From: Scott Fitinghoff <sfitinghoff@cornerstoneearth.com>
Sent: Thursday, December 27, 2018 10:33 AM
To: Sherry Liu
Cc: Jack Chamberlain; Camille Leung; Steve Monowitz
Subject: RE: BLD2016-00160, 2185 COBBLEHILL PL, LOT 9 SAN MATEO
Attachments: 230-1-6 Geotechnical Consultant Review Form Part 1 Signed 12-27-18.pdf

Subject: BLD2016-00160, 2185 COBBLEHILL PL, LOT 9 SAN MATEO

The Geotechnical Section of Planning and Building Department has conditionally approved the 11/21/2018 plans submitted for Lot 9, which included the riprap details for Lot 10, and 11/27/2018 plans submitted for Lot 11. Please make sure that the final riprap details for Lot 10 match the approved ones in Lot 9.

Date: November 15, 2018
Project No.: 230-1-6
Prepared For: Mr. Jack Chamberlain
TICONDEROGA PARTNERS, LLC
655 Skyway, Suite 230
San Carlos, California 94070
Re: Geotechnical Consultation and
Response to County of San Mateo
Geotechnical Comment
Highlands Estates (Lots 9 and 10)
San Mateo, California
County of San Mateo Geotechnical File Number
BLD2016-00158--00164

DRAWING NAME: K:\Projects\950168.dwg EXHIBITS\2018-11-06 Geotechnical Exhibits\C9.71-HECDDT.dwg PLOT DATE: 11-08-18 PLOTTED BY: hait

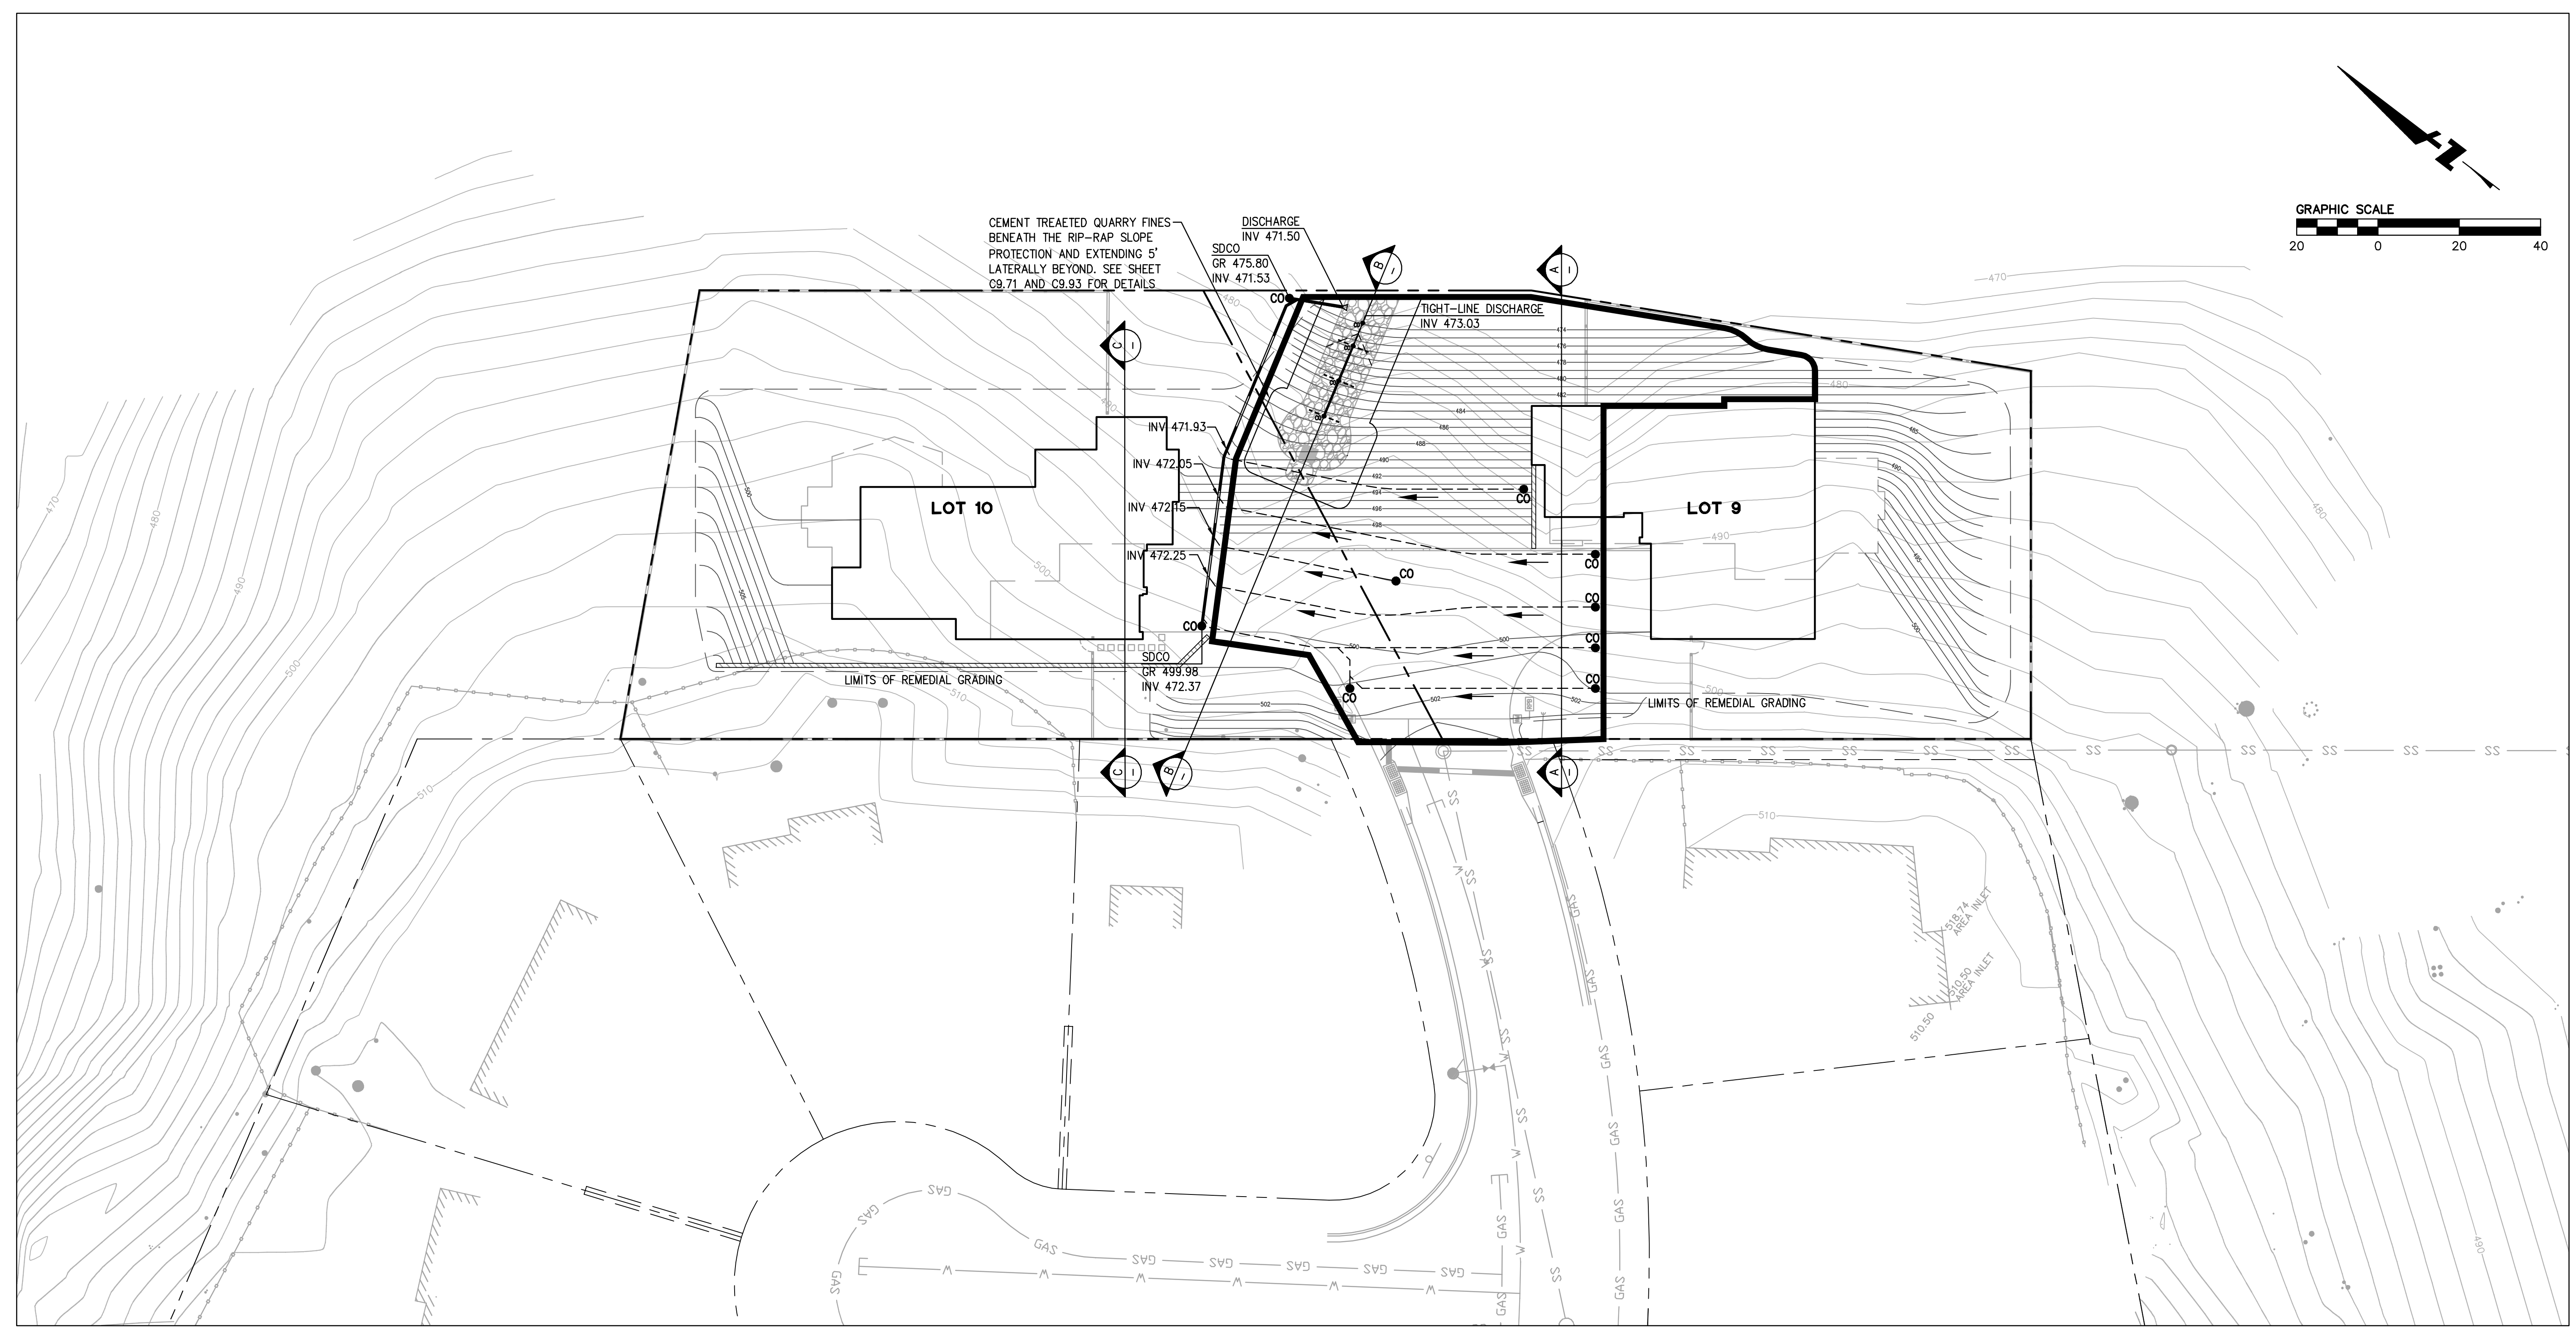
Comment #1: *As the slope below the riprap is 2:1 as shown on BKF Sheet C9.71 for Lot 9 (dated 10-8-18), if water must be discharged across the face of a steep fill slope, then County requires the implementation of one of the following measures:*

As we discussed, the project owner would like to implement the first option to address the above comments. As shown on Sheets C9.71 and C9.93 of the project Civil Plans, the rip rap slope protection will be underlain Marifi FW 700 geotextile fabric or approved equal. We do not recommend the rip rap be hard grouted because that will reduce rock's function of dissipating energy and slowing down the water after being discharged into the rock lined channel. As an alternative to grouting the rock to create an impermeable barrier to isolate the surface water from the underlying fill material, we recommend placing a select fill material consisting of quarry fines mixed with cement beneath the rip rap and geotextile fabric. We have made revisions to Sheets C9.71, C9.91 and C9.93 (see attached) showing the thickness and lateral extent of the select fill material beneath the rock lined channel. We recommend that the Quarry Fines from Stevens Creek Quarry be mixed with bulk cement on-site, moisture conditioned and compacted as recommended in our report. We recommend about 3 percent cement (i.e. 4 pounds of cement per cubic foot of Quarry Fines, compacted in-place). The spreading of the cement would likely need to be done by hand at the job site prior to the placement in the fill. Our representative should be on-site during placement to verify the percentage of cement being used in the fill as well as monitoring mixing of the cement, moisture conditioning, and compaction. The material should be compacted within 2 to 4 hours of the initial mixing of the cement. The cement treated select fill material would not be subject to soil creep.
